# SERVICE BULLETIN

ROLLER INCURL OIL APPLICATOR

No. 218.1

### ROLLER INCURL LUBE ASSEMBLY UPGRADE PMC-1001 & PMC-1002

#### ROLLER INCURL LUBE ASSEMBLY

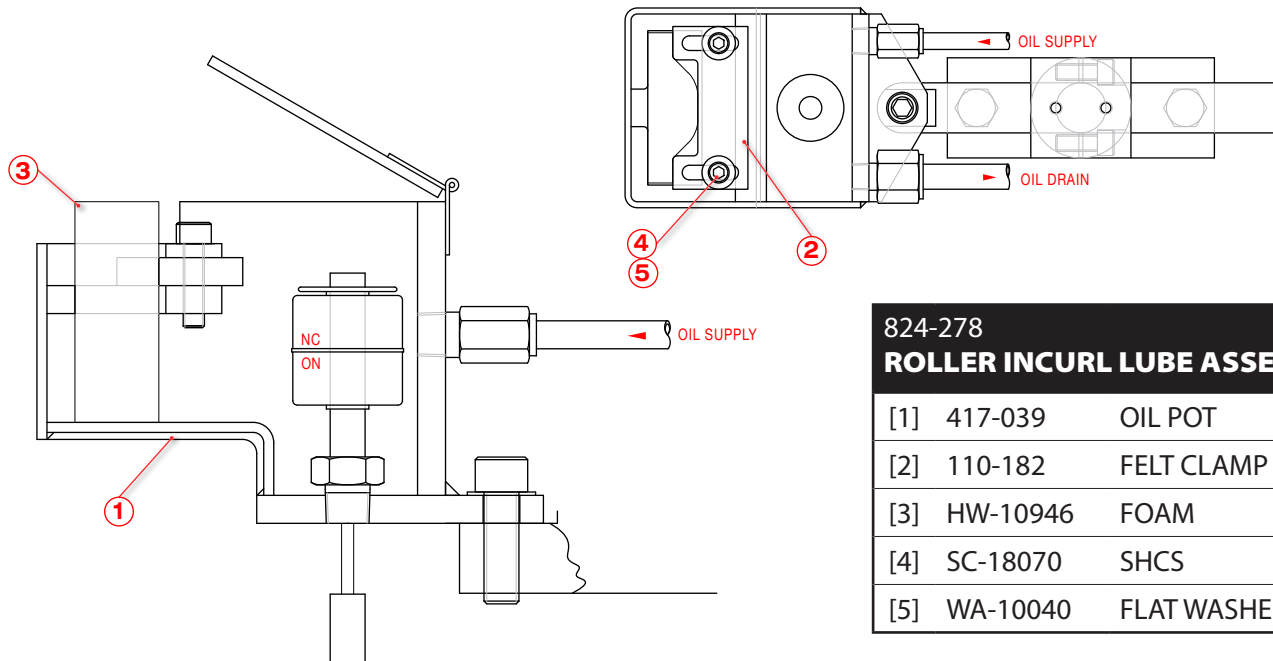
Paper Machinery Corporation is pleased to offer a new-and-improved Roller Incurl Oil Applicator for the PMC-1001 and PMC-1002 model machines. The Roller Incurl Oil Applicator can be purchased from PMC's customer service department under Assembly #824-278.

A wider pot design accommodates a larger piece of Foam. This foam is highly resistant to wear and is more absorbent, which allows the Foam to stay wet much longer. The larger width of the foam provides an improved uniform application of the oil to the cup bottom.
